DE HAVILLAND

STANDARDS SHEET

DRAWN	HANDLEY	CLASSIFICATION	STANDARD
CHECKED	[Signature]	P SECTION	ZVR 129
STRESSED	[Signature]	EXTRUDED RUBBER	
APPROVED	[Signature]

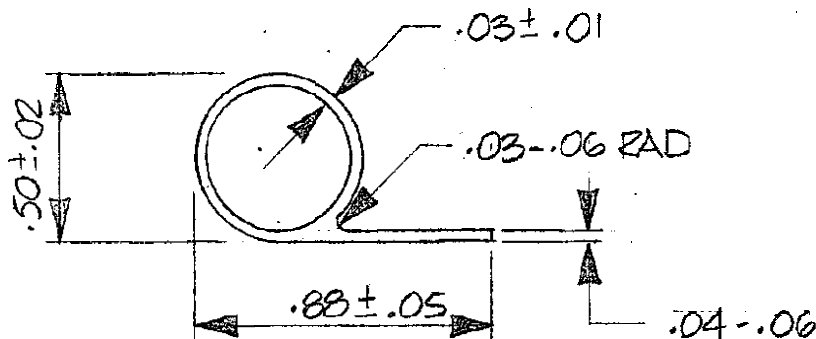
REQUIREMENT CHANGED
TO FAR RULE.
15/9/86 D.C. [Signature]

AMS 3802 WAS DUNS PI. 34-2 CR 2.
COLOR NOS. 27038 BLACK
WAS 20045 BROWN. [Signature]
R. 18. 20 SEPT 84

- (A) MAT'L: AMS 3802 SILICONE
MIN. LENGTHS: 7FT OR INCREMENTS THEREOF.
REF INFO: SILICONE RUBBER
(A) BLACK FED STD
#595 COLOUR #27038

- (B) FLAMMABILITY: FAR 25.853 (b-2) AND 25-51
ENG. APPROVAL IS REQD PRIOR TO
PROD. RUN.
RUBBERCRAFT DIE N°: 1602
